RESPONSE TO SUBMISSIONS

RESPONSE TO SUBMISSIONS (RTS)

This RTS will only address issues that are still relevant to the Preferred Project. As such there will be no response to issues surrounding the originally proposed longwalls in the Wonga West area, the Wonga Mains, or the Bulli and Balgownie West 1st workings. Those particular issues will be reviewed and addressed as part of a future development application to the DPI.

Figure 65 - Delivery Area for Community Newsletter Advising of the Public Exhibition of the EA

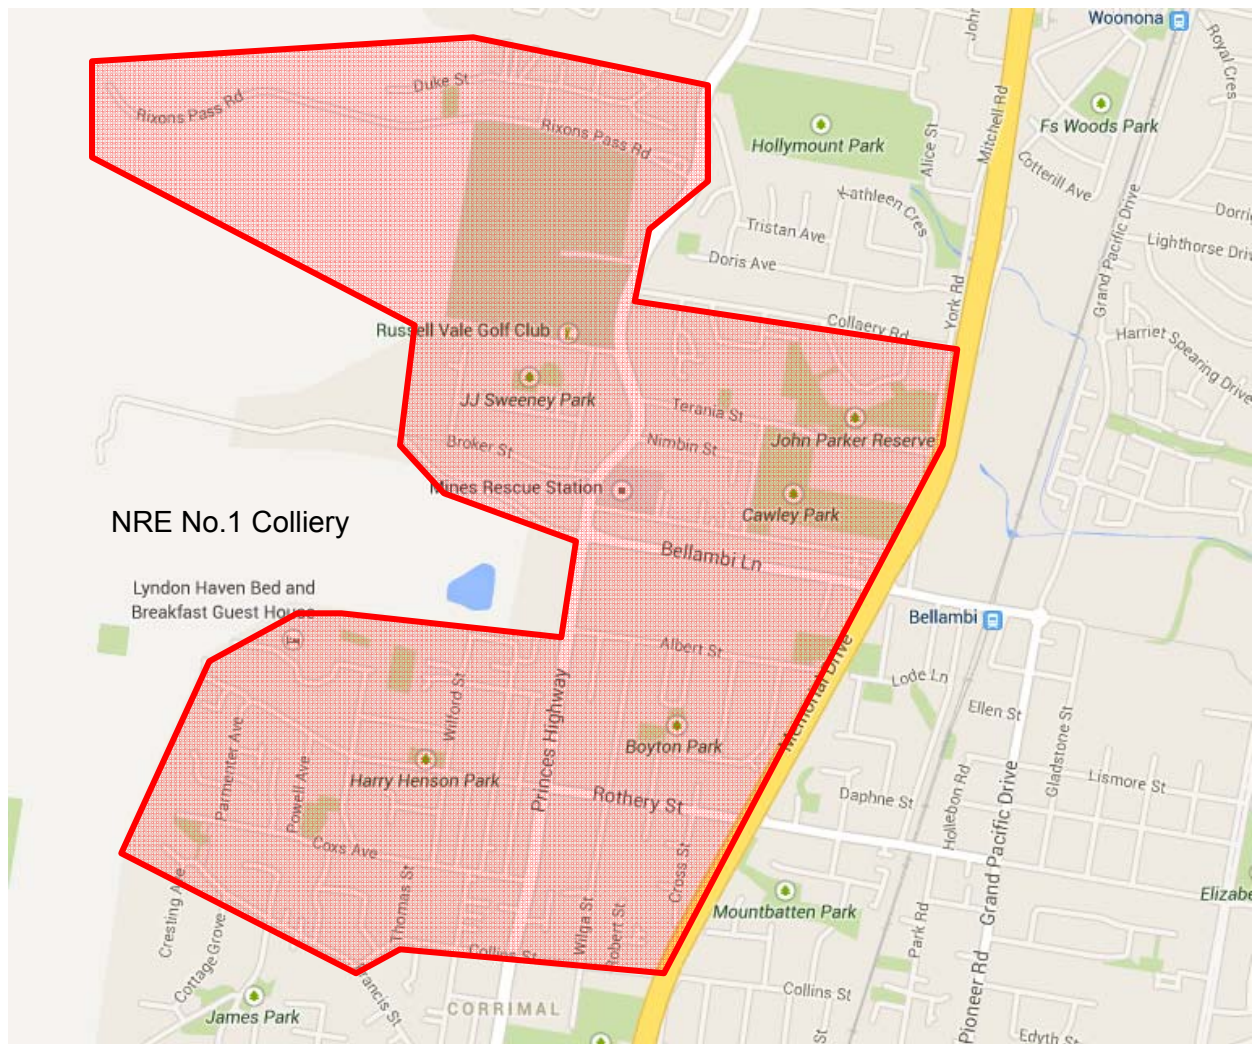
- a. a community information day prior to the public exhibition of the EA;
- b. a display of the EA at the Russel Vale Golf Club; and
- c. a community newsletter advising of the public exhibition of the EA including information on the 'stealthy' modification of certain items in the Preliminary Works Pt3A;

- c. A newsletter outlining the information requested by IRRM in the CCC was delivered on the 8th and 9th of March 2013 to a large number of surrounding residents as can be seen in **Figure 65**, pg 207. Although notification was not given to the community, the modification process was not undertaken in stealth. The matter was discussed with DPI and was subject to PAC determination.

Figure 71 - Process Followed by NRE in Addressing PSNL Exceedances

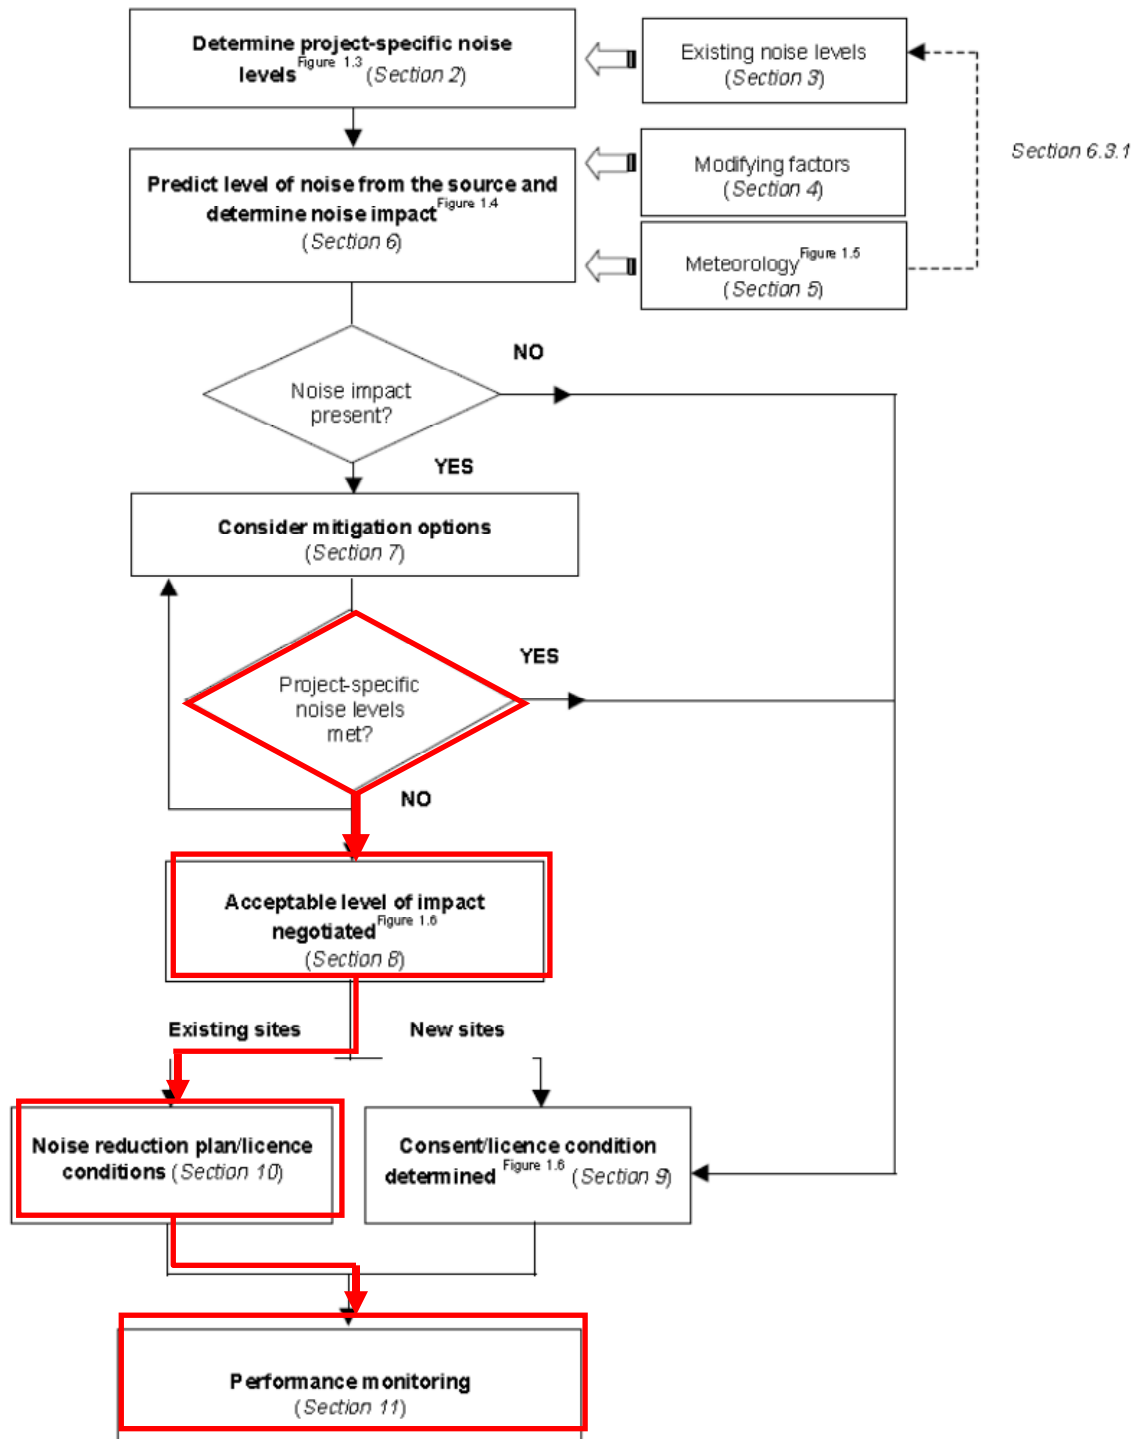
1. – *Section 8.1.1, pgs 30-31, of Annex H of the EA* predicts that there will likely be ≤ 2 dB(A) exceedance of the PSNL at three residential premises due to operational noise, exceedance of between 2.5 to 3 dB(A) at two residential premises due to peak truck movements and exceedances of up to 5 dB(A) at numerous receivers during construction. In this case NRE will follow the process as shown in *Figure 1.2 of the INP*. given that
 - a. NRE No.1 Colliery is an existing site undergoing upgrade;
 - b. the modeling of traffic noise is based on maximum possible truck movements; and
 - c. where the PSNL is exceeded but the exceedances are ≤ 5 dB(A);

A copy of *Figure 1.2 of the INP* is reproduced in **Figure 71**, pg 258, showing the pathway (outlined in red) that NRE will follow to manage any exceedances of the PSNL. This will include the use of a NMP that incorporates any conditional requirements from both the sites EPL and any DPI conditions of approval. This approach is entirely consistent with the INP and doesn't require any additional remodeling.
